Subject: Safety Defect and Noncompliance Report Guide for Equipment, PART 573 Defect and Noncompliance Report

On April 20, 2009, Petersen Industries, Inc. decided that a defect which relates to motor vehicle safety exists in Petersen RS3 "Rear Steer" grapple trucks and is furnishing notification to the National Highway Traffic Safety Administration in accordance with 49 CFR Part 573 Defect and Noncompliance Reports. This is an initial report. No manufacturer's identification code for this recall has been issued.

## Important Safety Notice – Product Improvement

### Model RS3 Grapple Trucks

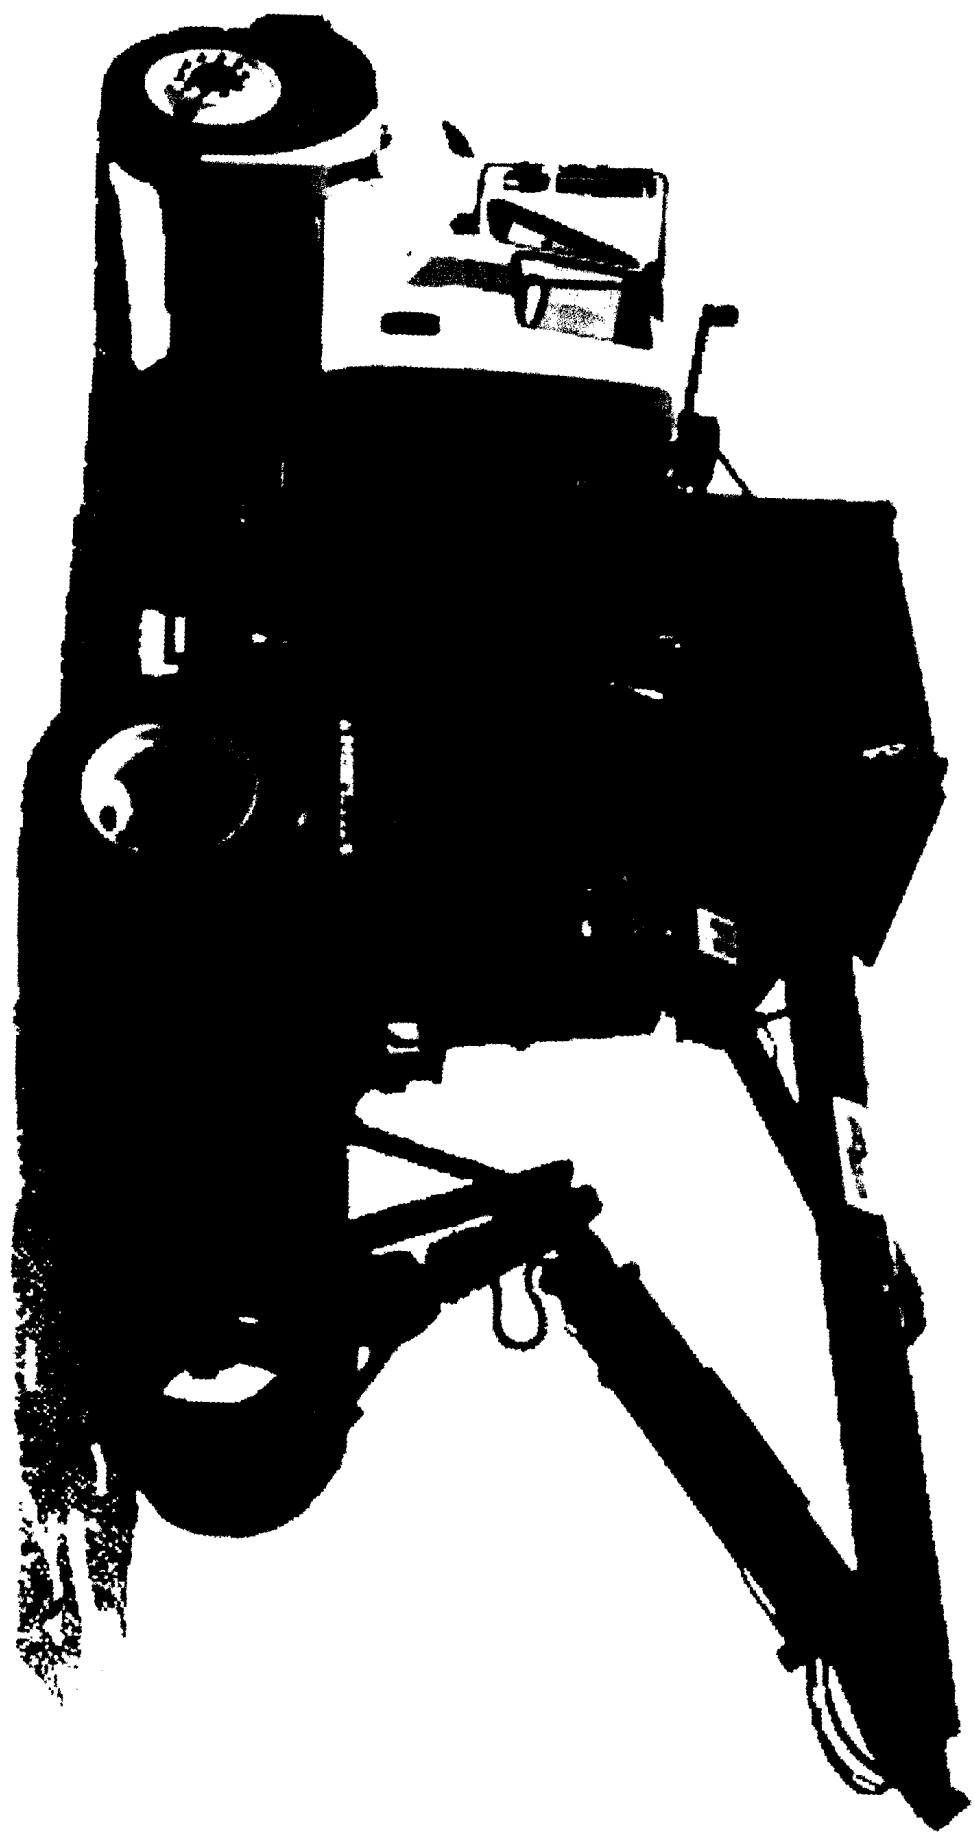
**Under long-term use, the spindle portion of the head assembly in a Petersen Model RS3 Grapple Truck may develop cracks resulting in failure of the spindle. A spindle failure could result in the boom separating from the pedestal without warning, and could result in serious injury or death.**

- **The head assemblies on the above listed unit(s) must be replaced prior to putting the unit(s) back into service.**
- **Failure to take the Petersen Model RS3 Grapple Truck(s) listed above out of service could cause an accident resulting in severe injuries or death.**
- If you have transferred possession of a Petersen Model RS3 Grapple Truck, notify the current owner immediately. Also, notify Petersen toll free at 800/930-5623, ext. 227.
